Access Compliance Report

Public Rights-of-Way

Intersection ID: 6526	Main Street: CENTURY_OAKS_LN	Cross Street: MINERAL_SPRINGS_RD	Location: SE
ADA ID: 0B3F938672CD	Ramp Type: BlendTrans1	Initial Pass/Fail: Fail	Overall Compliance: No
Severity Score: 8.75			
Codes/Mitigation Info/Possible Solution		Field Measurements/Component Compliance

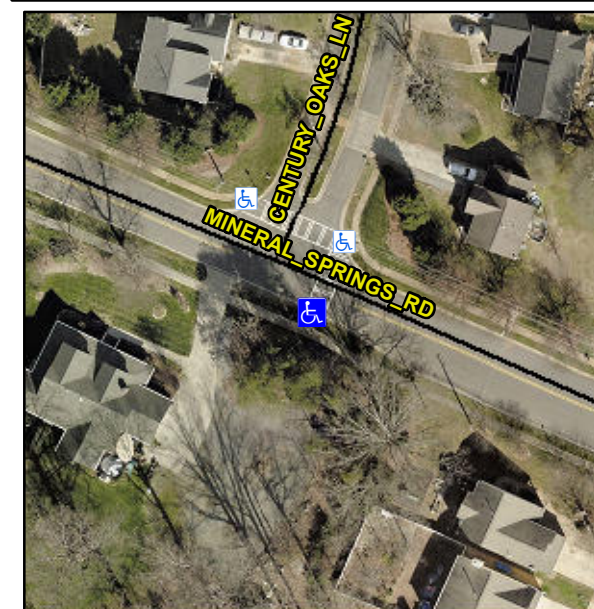
NO CURB, LNDG GAP 1.0

R304.5.1

Remove & Replace Curb Ramp With Two New Directional Ramps or Equivalent.
